ARCHITECTURAL REVIEW BOARD MEETING

NOVEMBER 14, 2023 IN THE CITY COUNCIL CONFERENCE ROOM AT 5:00 PM

PLANNING AND ZONING COMMISSION CASE MEMO

TO: Planning and Zoning Commission
DATE: November 14, 2023
APPLICANT: Salvador Salcedo
CASE NUMBER: SP2023-032; *Site Plan for 855 Whitmore Drive*

DATE: 04/11/2022
 DRAW BY: F.G.M
 SHEET 05 OF 00

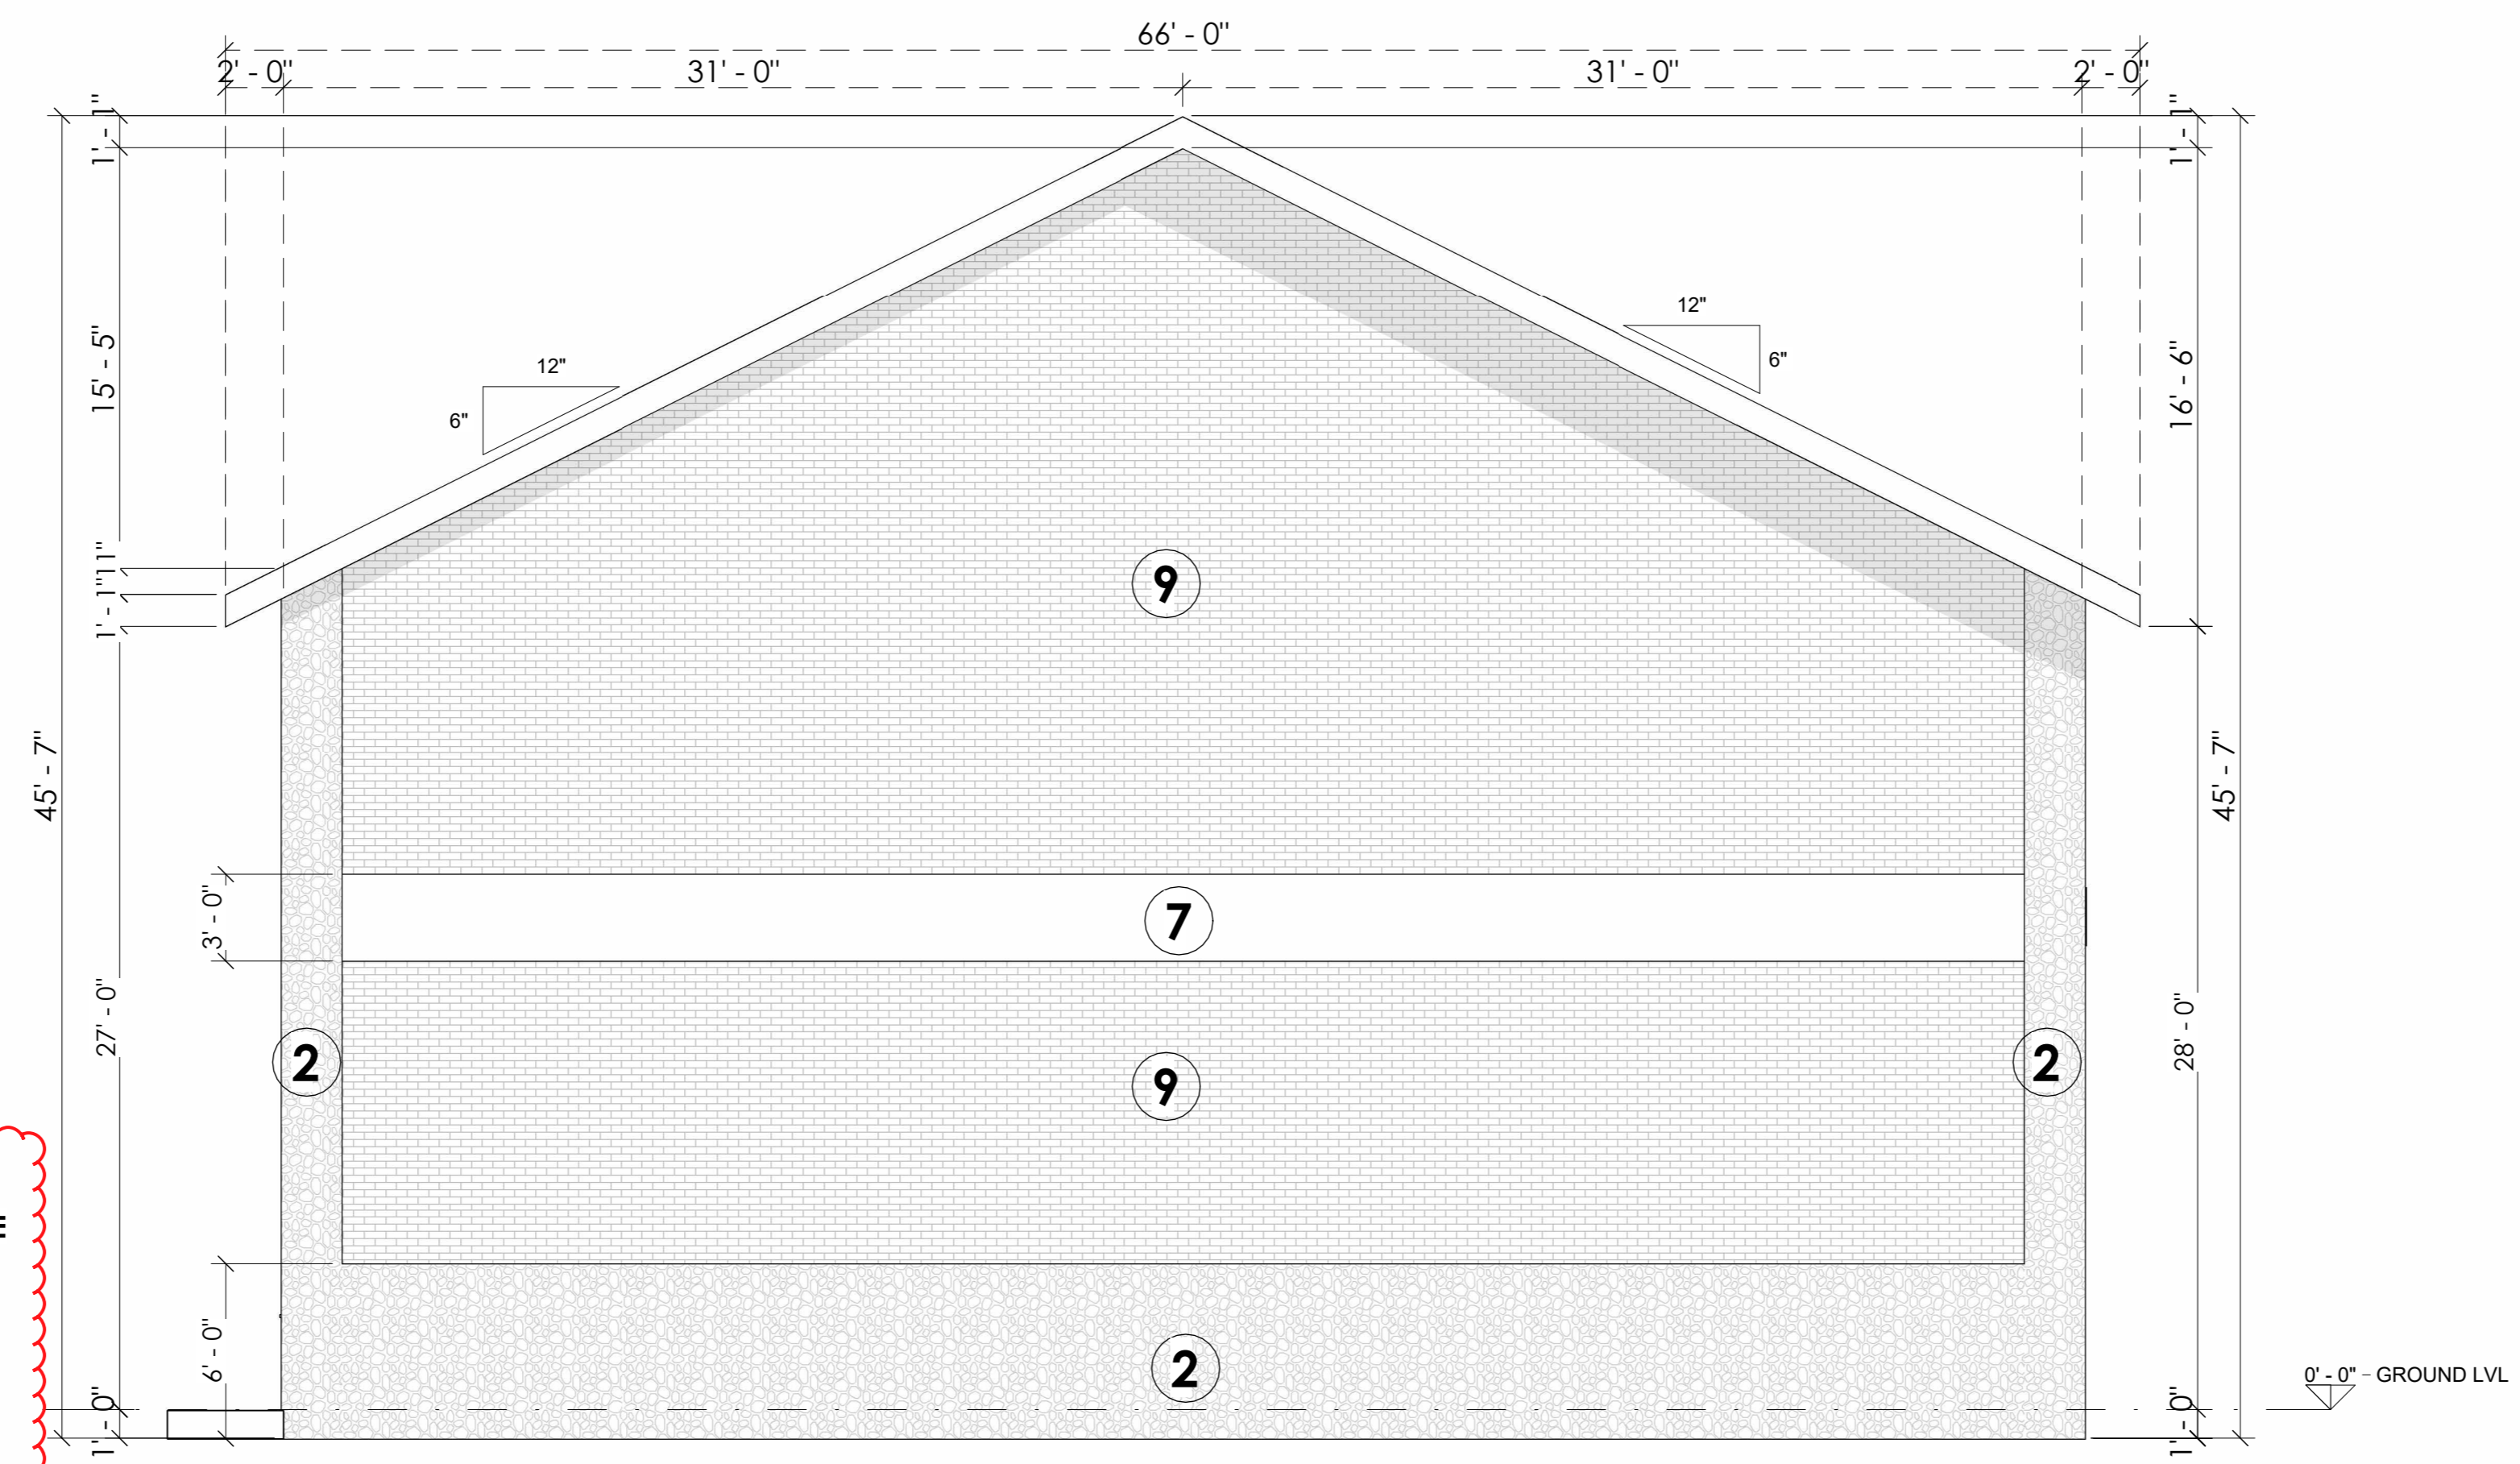
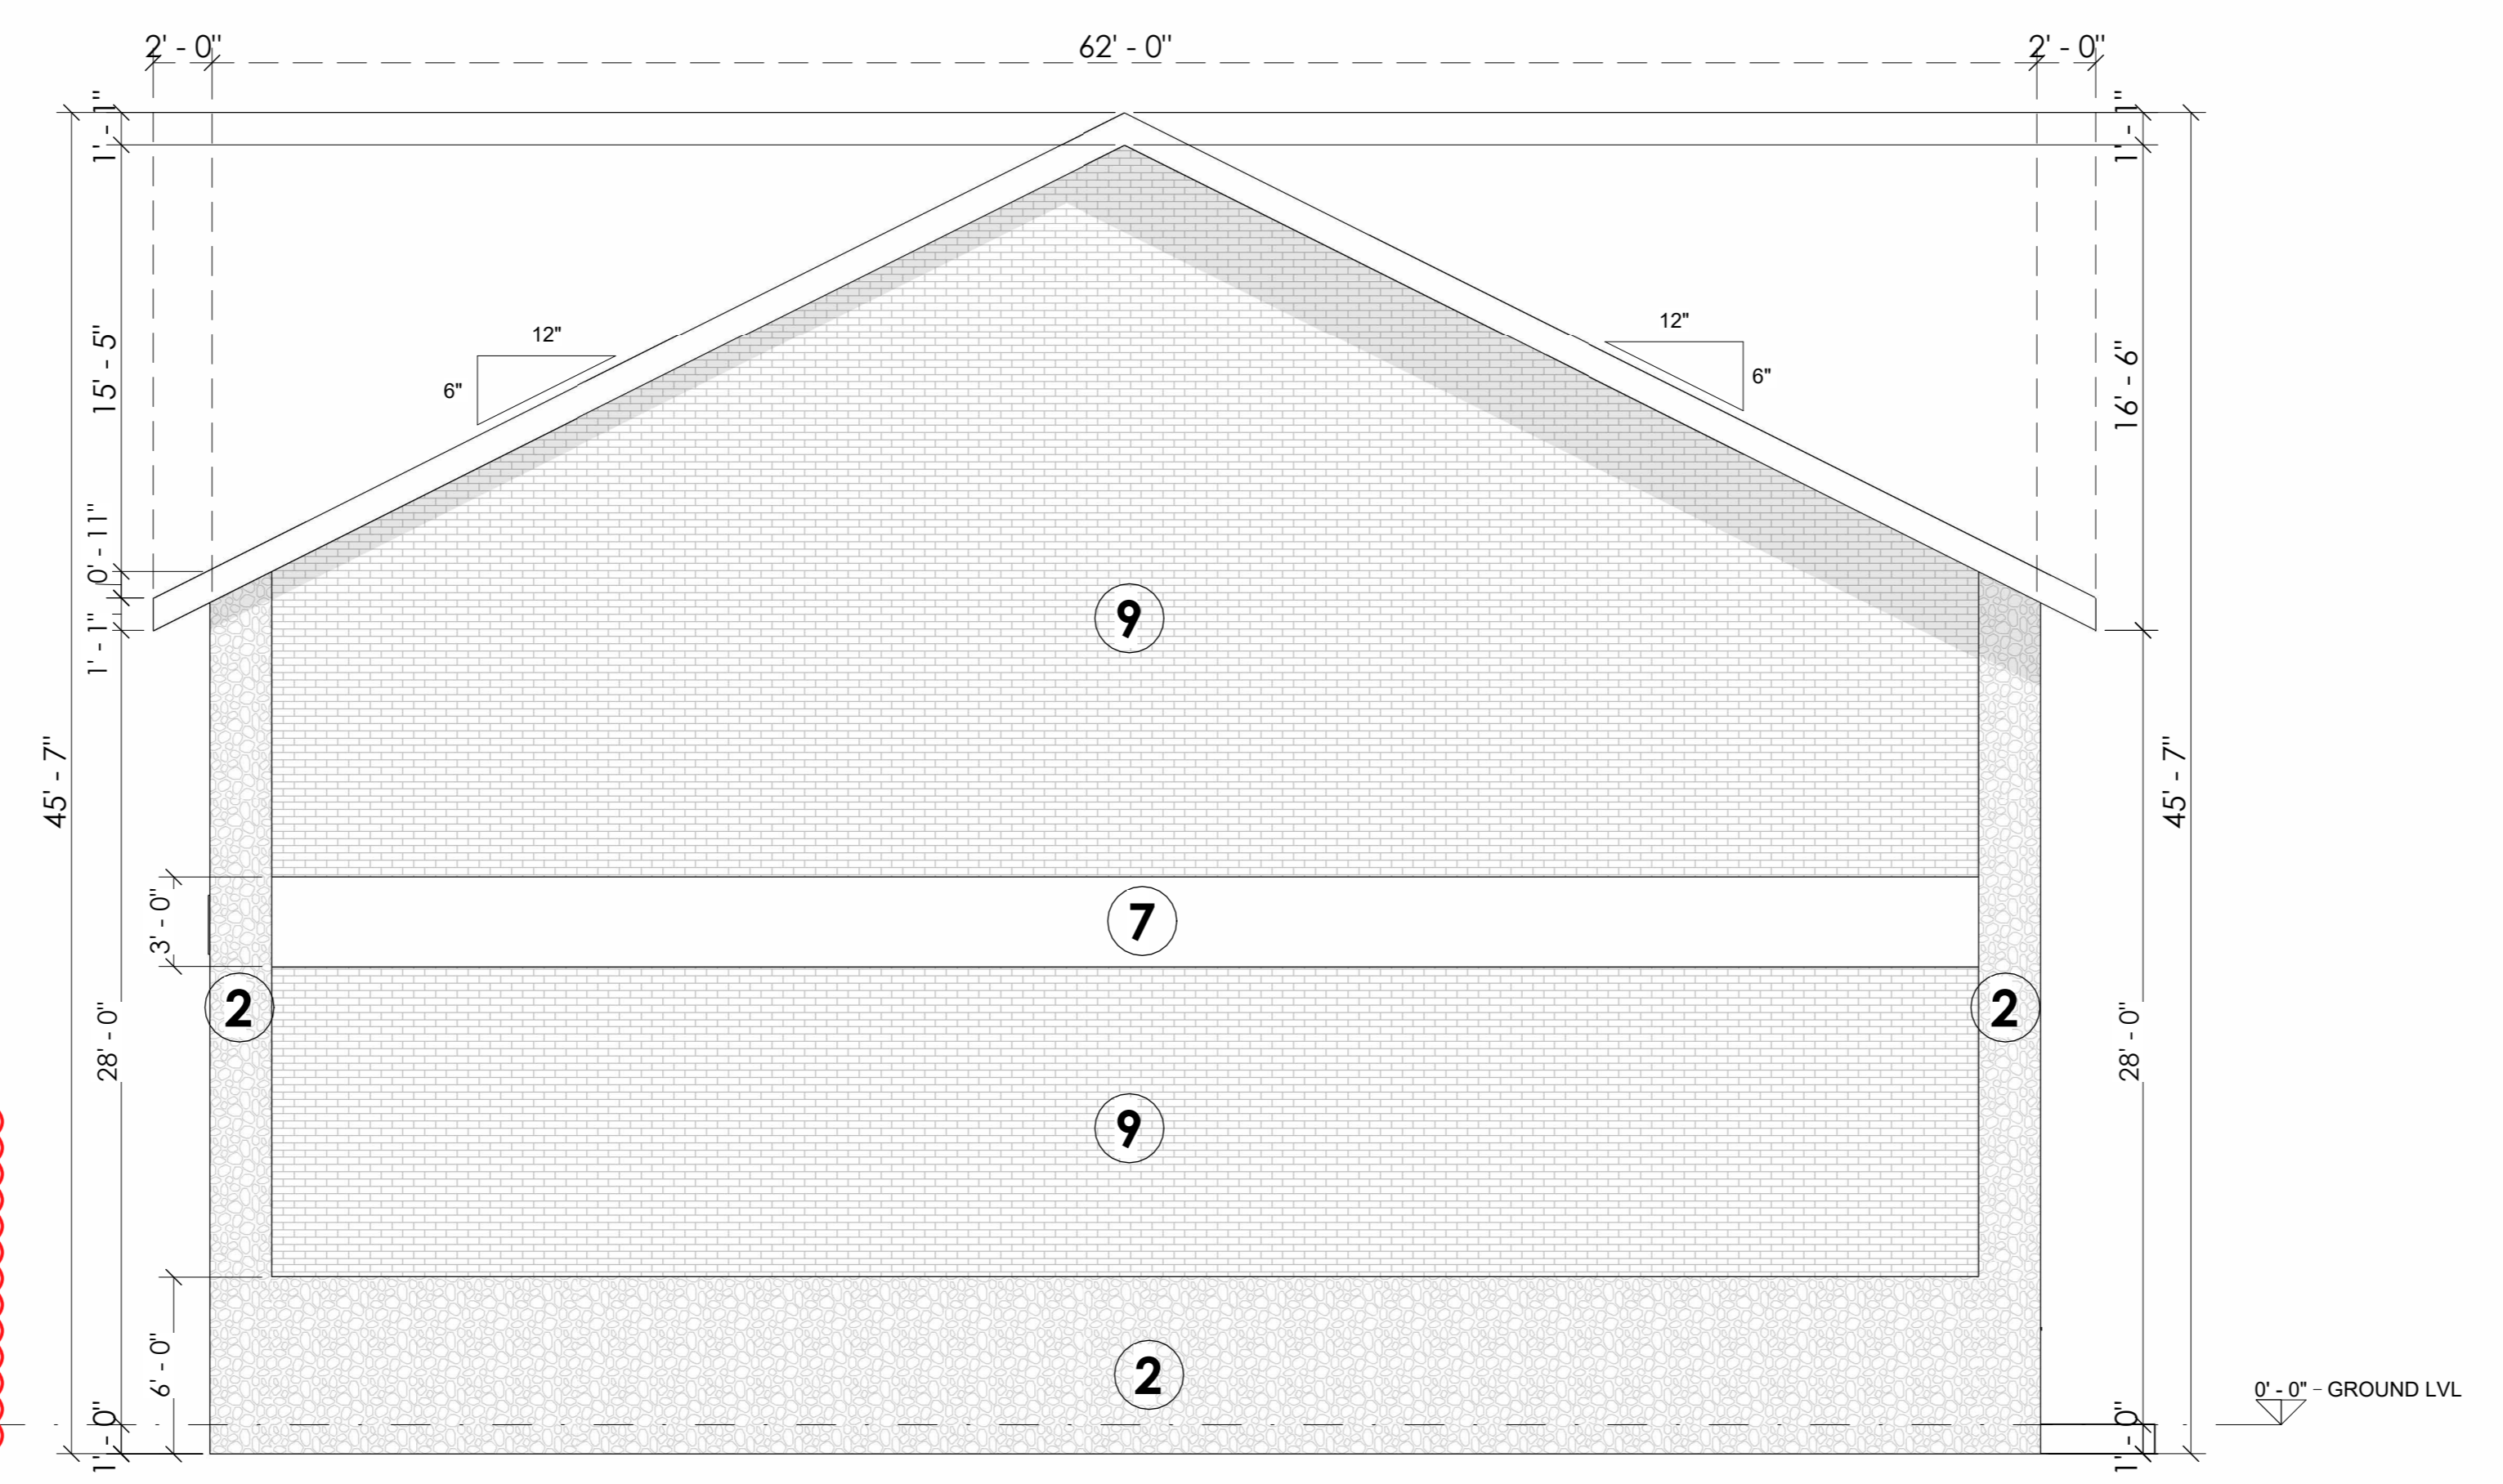
- (a) Primary and Secondary Building Facades. According to Subsection 05.01 (C), *General Industrial District Standards*, of Article 05, *District Development Standards*, of the Unified Development Code (UDC), for primary building facades a wall projection should extend 25.00% of the wall height above and away from the wall, and for secondary building facades a wall projection should extend 15.00% of the wall height above and away from the wall. In this case, the proposed building does not meet the projection requirements. This will require an exception from the Planning and Zoning Commission.

REV. NO.	DATE	COMMENTS
2	09/30/2023	a) INCLINACIÓN DEL TECHO CORREGIDA DE 3:12 A 6:12 b) THE WALL LENGTH REQUIREMENTS FOR THE NORTH, EAST, WEST AND SOUTH FACADES WERE CORRECTED c) THE MATERIALS AND PERCENTAGES OF MATERIALS WERE CORRECTED ACCORDING TO THE ESTABLISHED REQUIREMENTS
3	11/06/2023	A) TABLE OF AREAS AND PERCENTAGE OF MATERIALS WAS ADDED
